PROPOSED IMPROVEMENT
BRIDGE PROJECT

VT ROUTE 100 - (MINOR ARTERIAL) BRIDGE NO : 68

RECORD PLANS

PROJECT NAME : WARDSBORO
PROJECT NUMBER : BRF 013-1(15)

PLOT DATE: 06-OCT-2015
DRAWN BY: R. PELLETT
CHECKED BY: D. PETERSON
SHEET 3B OF 51

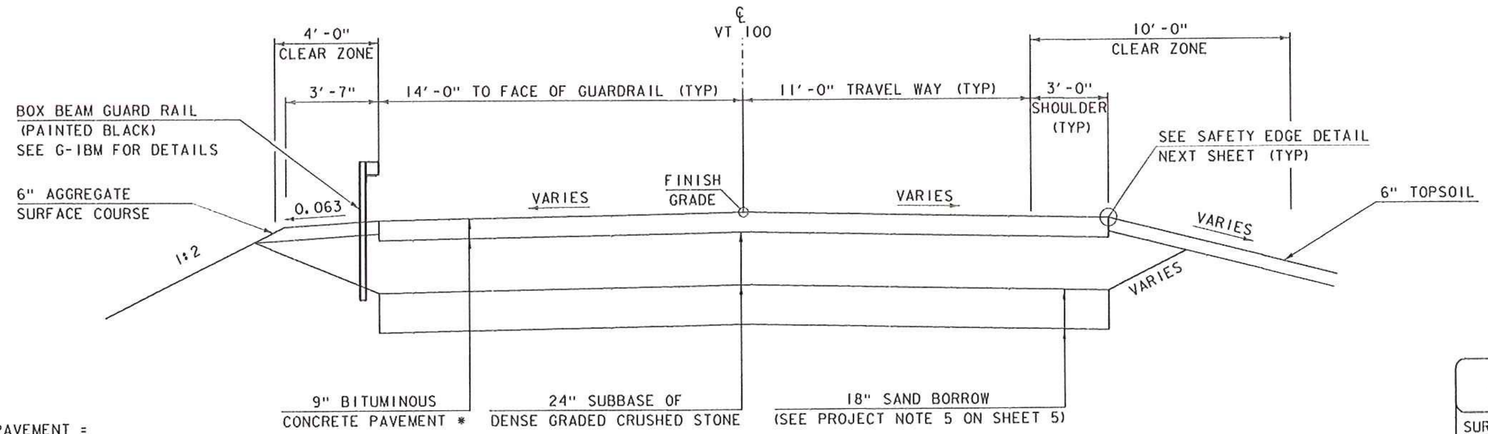
KEY	DATE	BY	REVISION
⚠	10/05/2015	VAOT	MODIFIED ROLLED BEAM TO PLATE GIRDER.

FILE NAME: s92b283sup.dgn
PROJECT LEADER: C. CARLSON
DESIGNED BY: D. PETERSON
DECK REINFORCING PLAN & TYPICAL
PLOT DATE: 06-OCT-2015
DRAWN BY: R. PELLETT
CHECKED BY: D. PETERSON
SHEET 25B OF 51

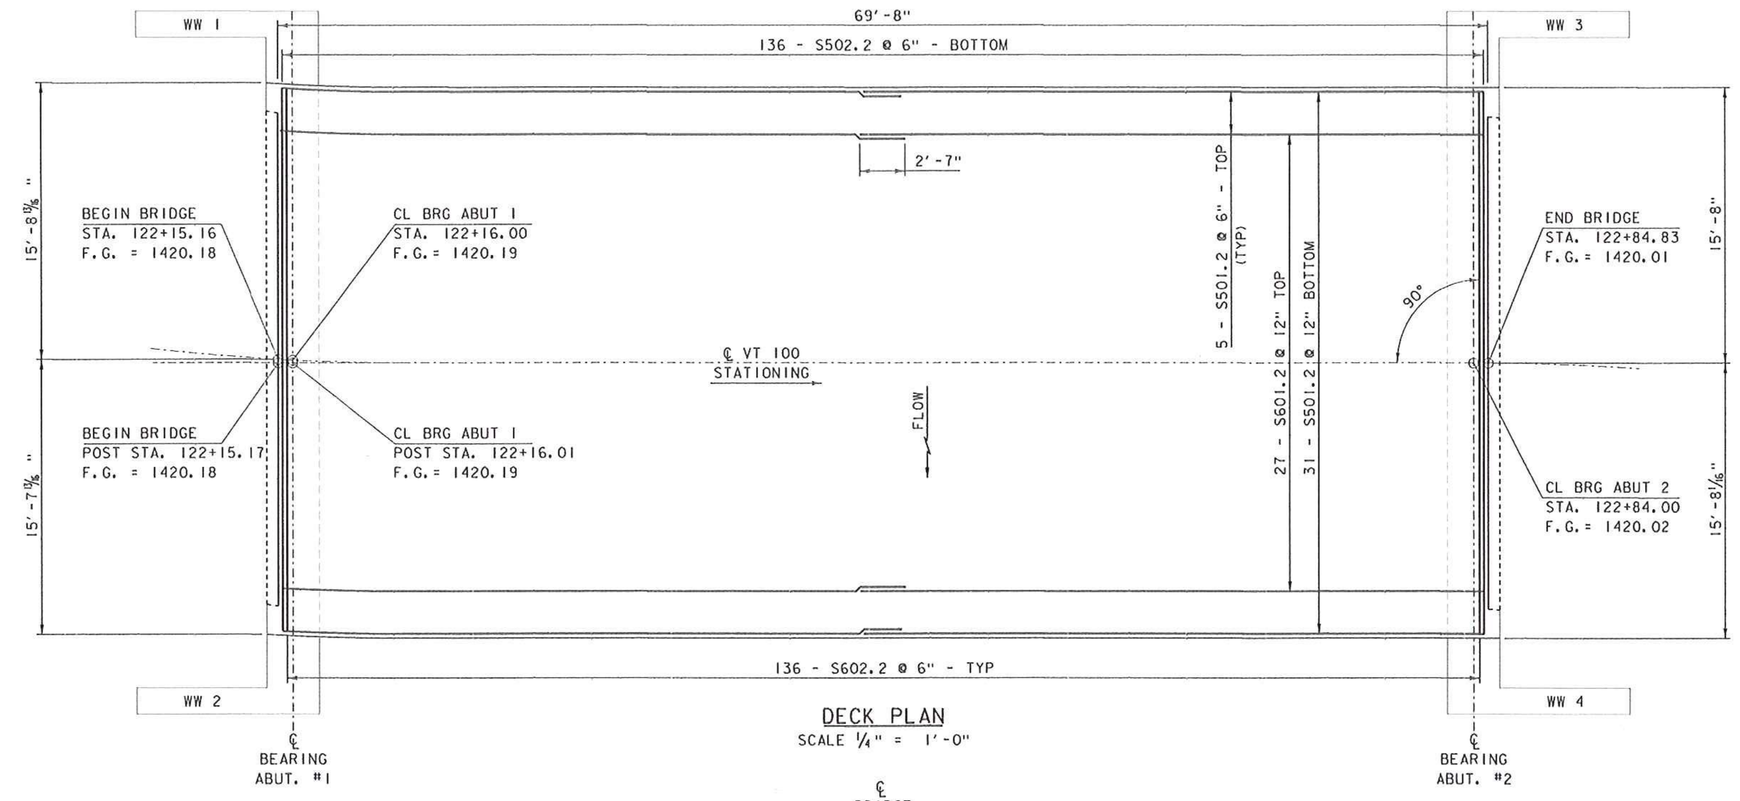
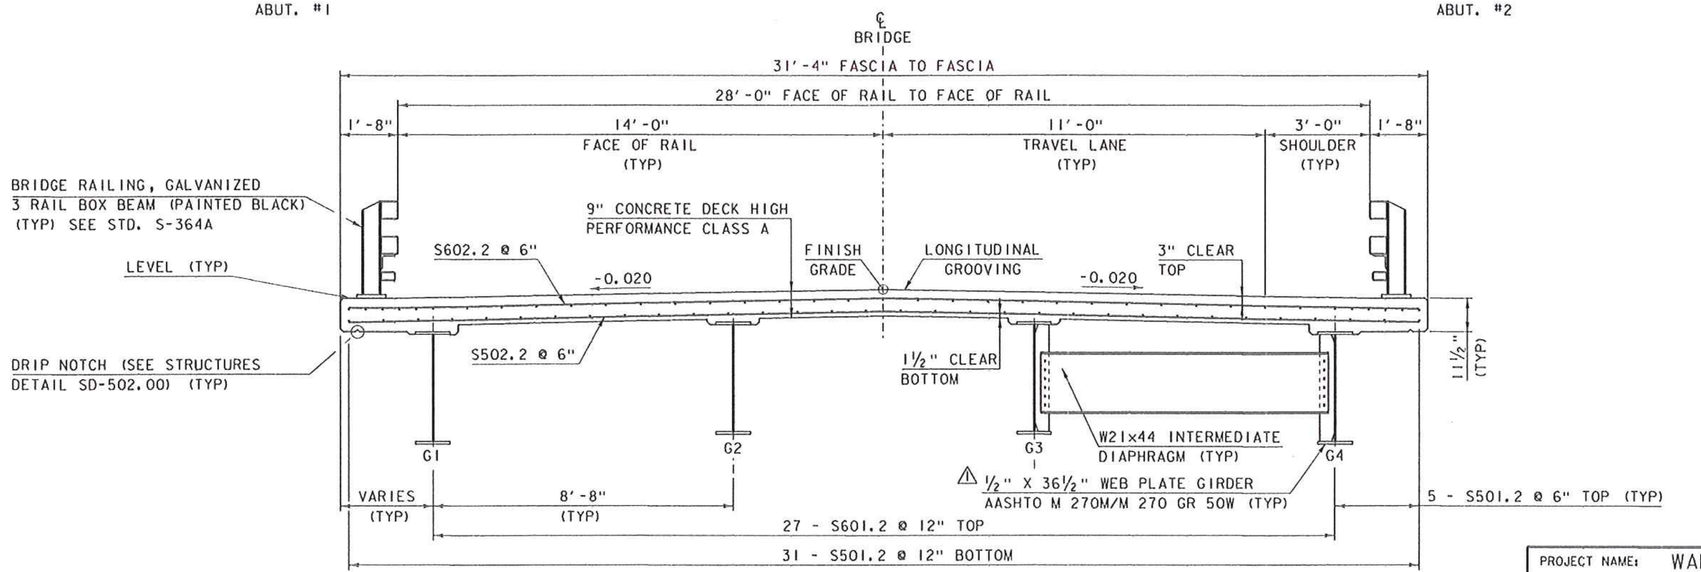
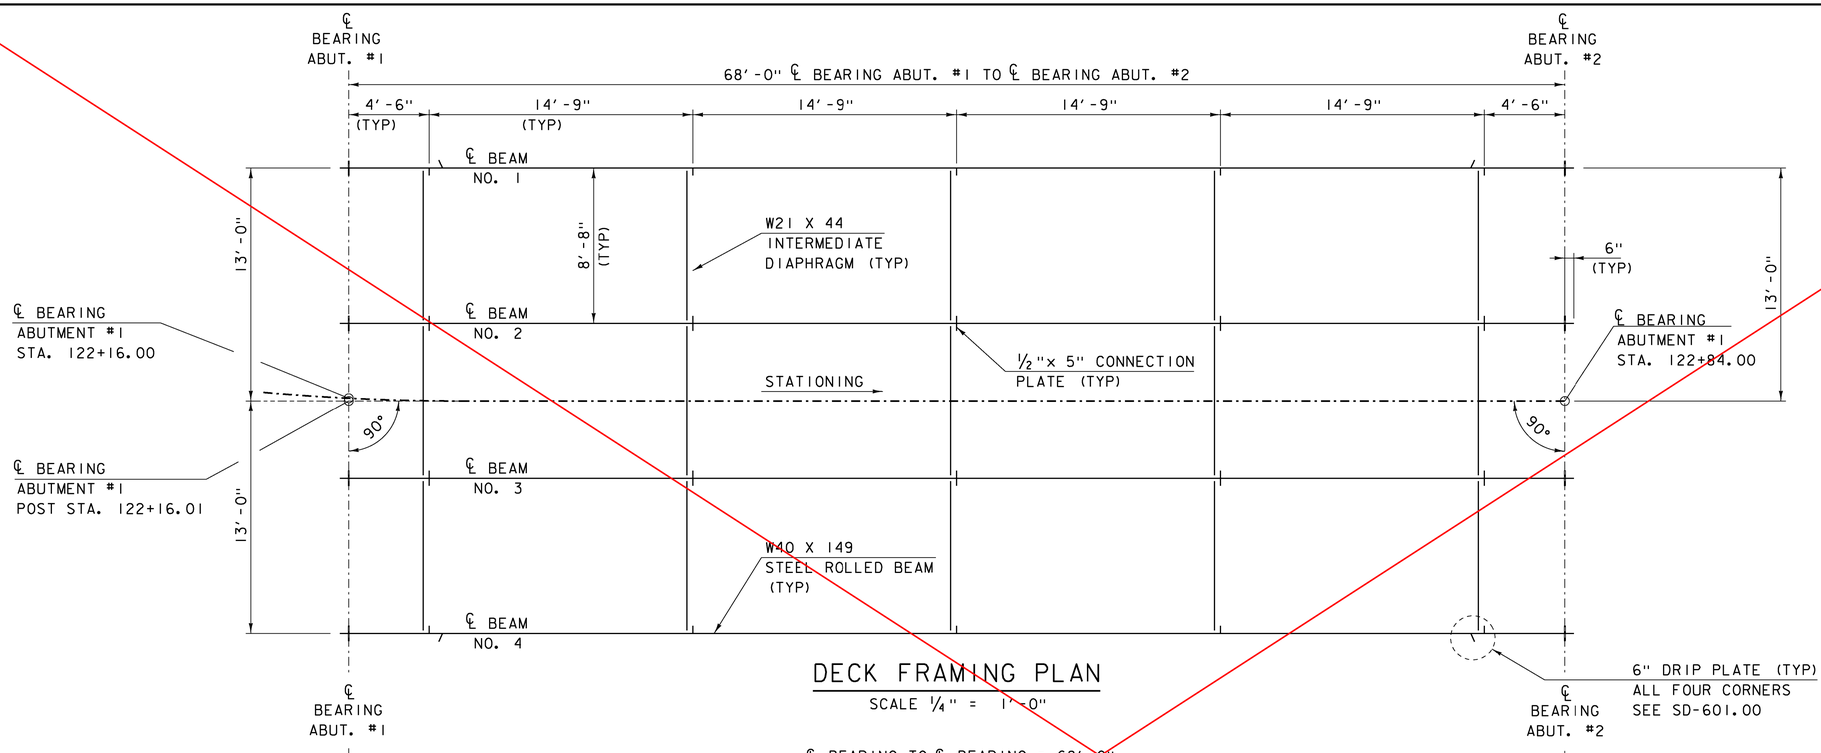
KEY	DATE	BY	REVISION
⚠	10/05/2015	VAOT	MODIFIED ROLLED BEAM TO PLATE GIRDER.

PLOT DATE: 08-OCT-2015
DRAWN BY: D. KARABEGOVIC
CHECKED BY: D. PETERSON
SHEET 26B OF 51

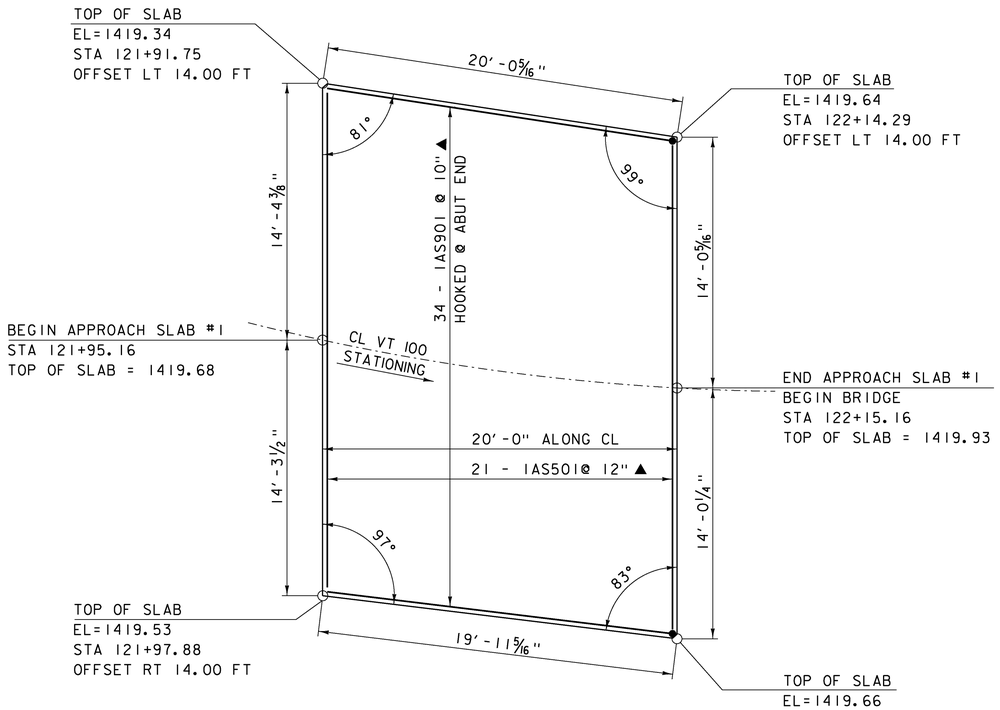
KEY	DATE	BY	REVISION
⚠	10/05/2015	VAOT	MODIFIED ROLLED BEAM TO PLATE GIRDER.

PLOT DATE: 06-OCT-2015
DRAWN BY: R. PELLETT
CHECKED BY: D. PETERSON
SHEET 28B OF 51

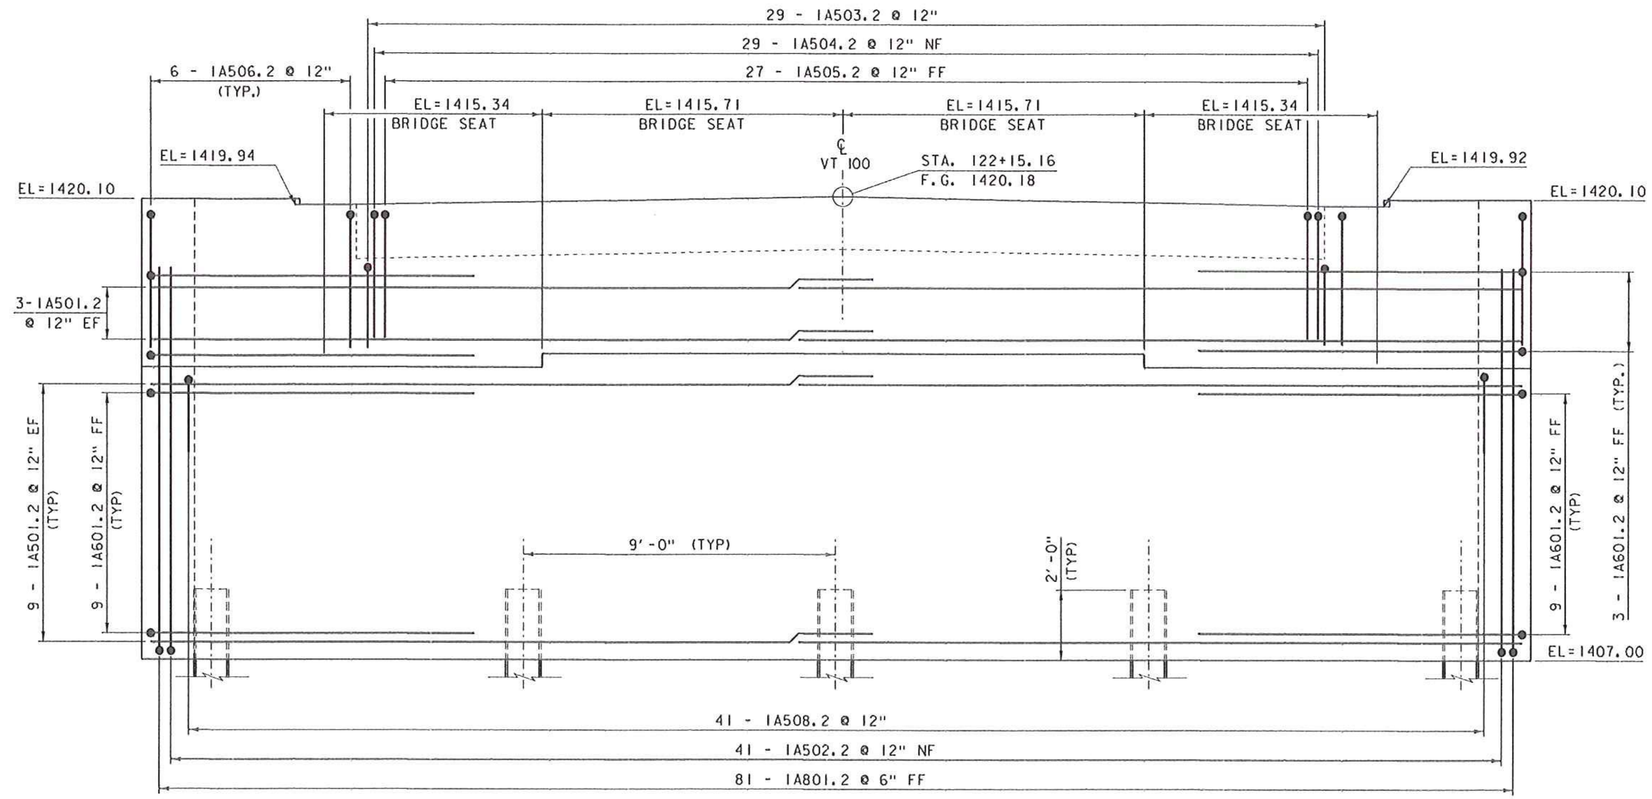
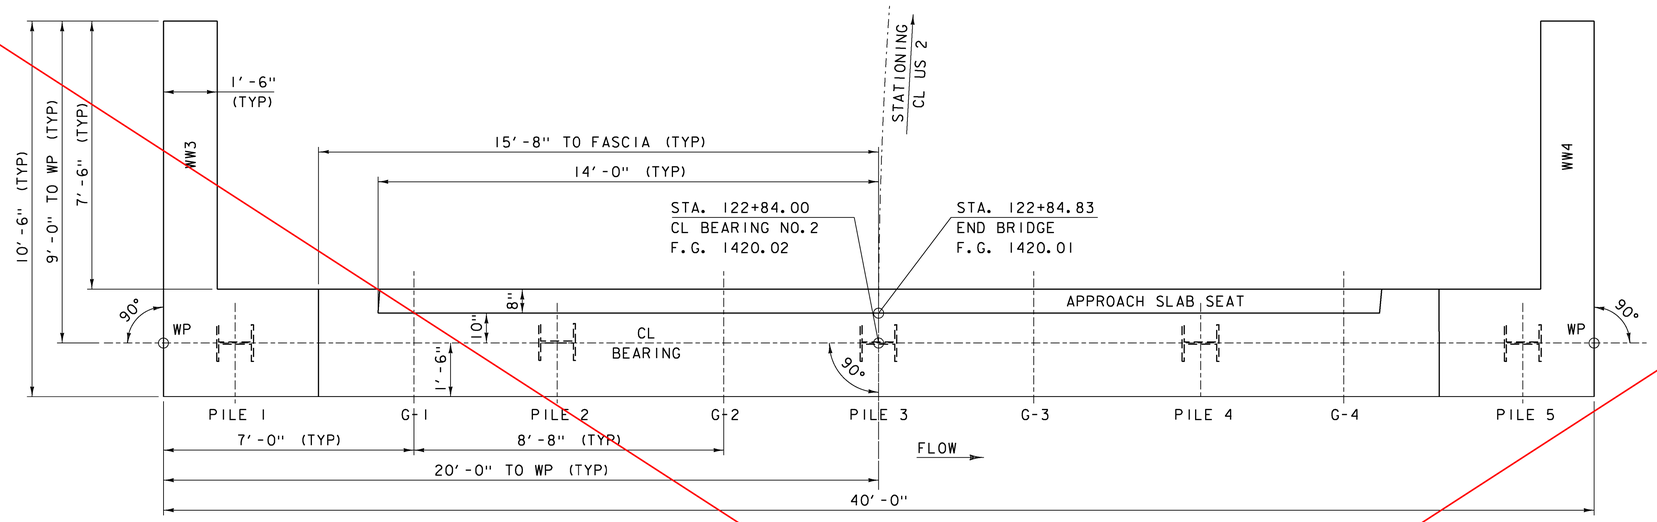
KEY	DATE	BY	REVISION
⚠	10/05/2015	VAOT	MODIFIED ROLLED BEAM TO PLATE GIRDER.

FILE NAME: s92b283sub.dgn
PROJECT LEADER: C. CARLSON
DESIGNED BY: D. PETERSON
PLOT DATE: 07-OCT-2015
DRAWN BY: R. PELLETT
CHECKED BY: D. PETERSON
ABUTMENT #2 PLAN & ELEVATION AND BEARING DETAIL SHEET 29 OF 51

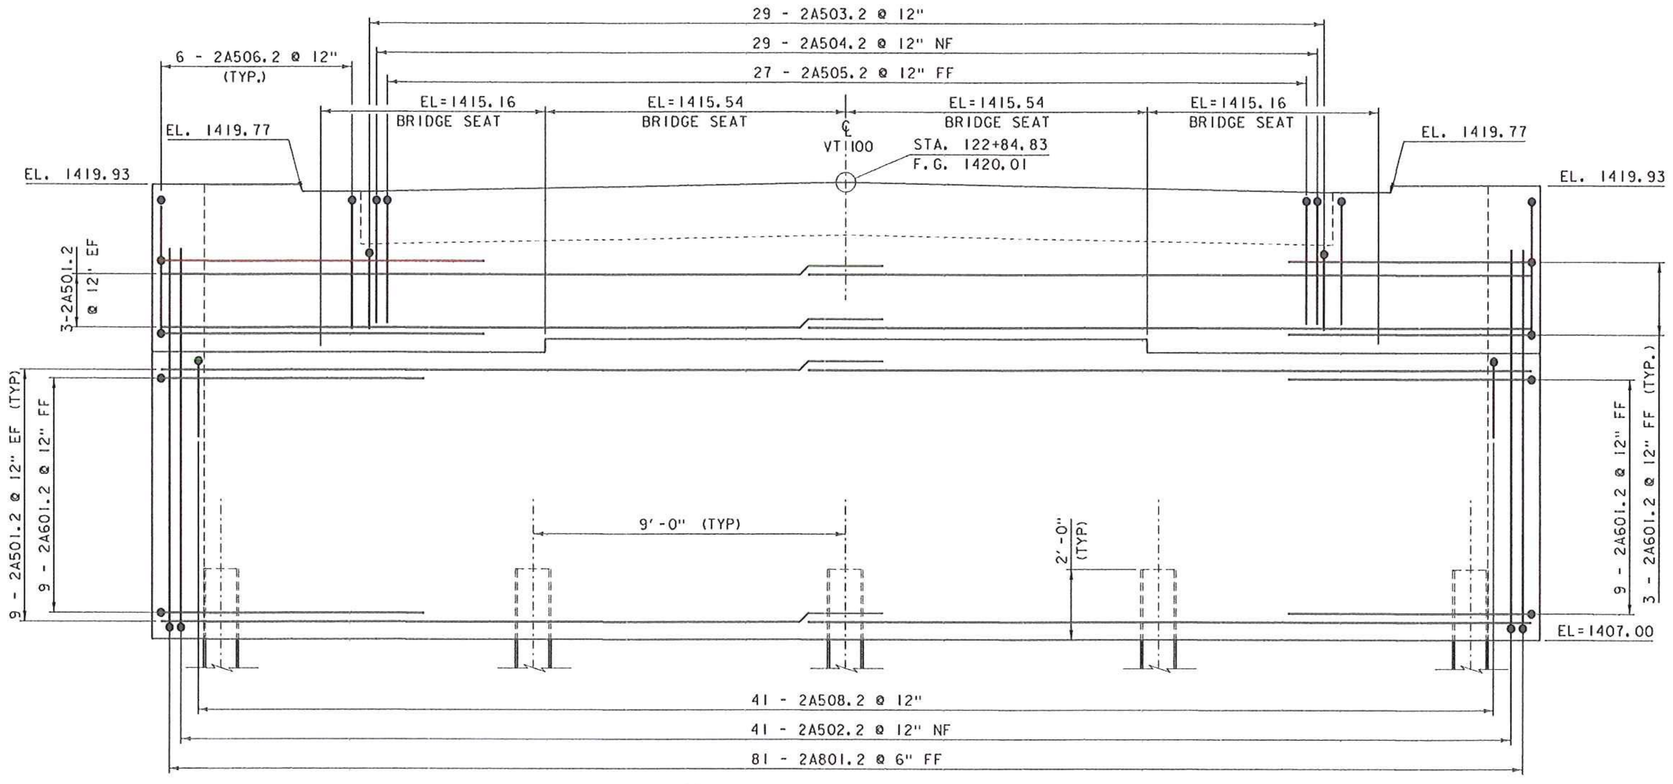
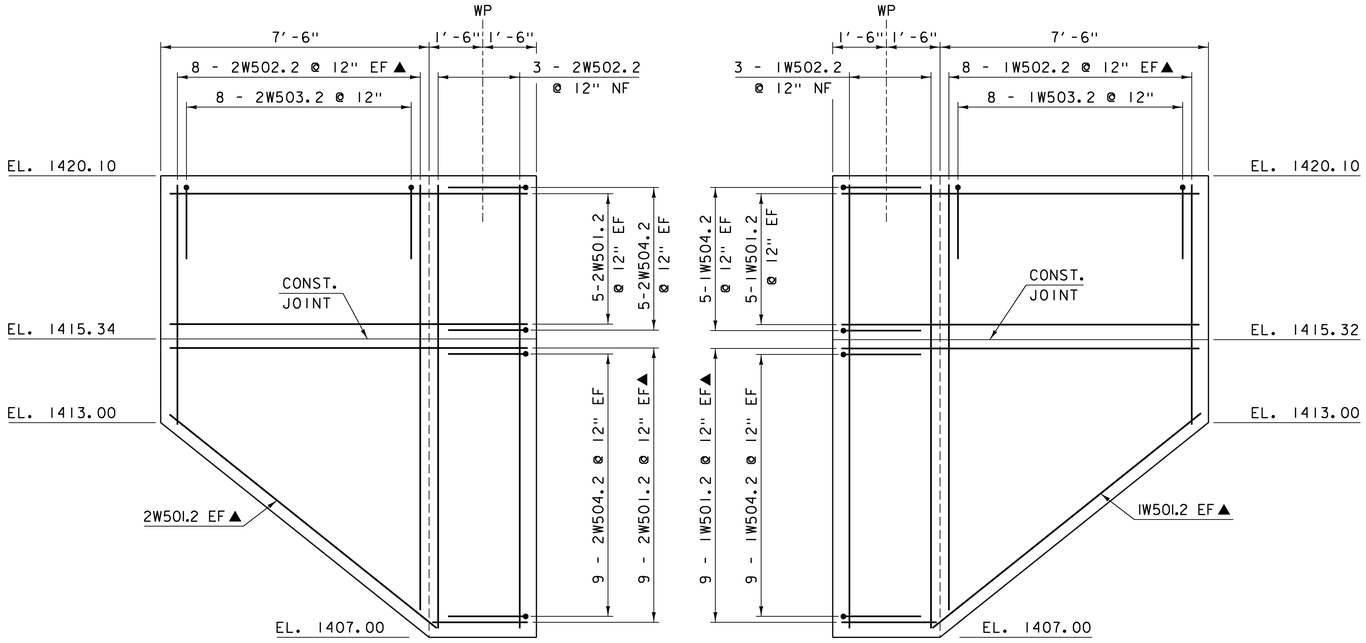
KEY	DATE	BY	REVISION
⚠	10/05/2015	VAOT	MODIFIED BEARING THICKNESS
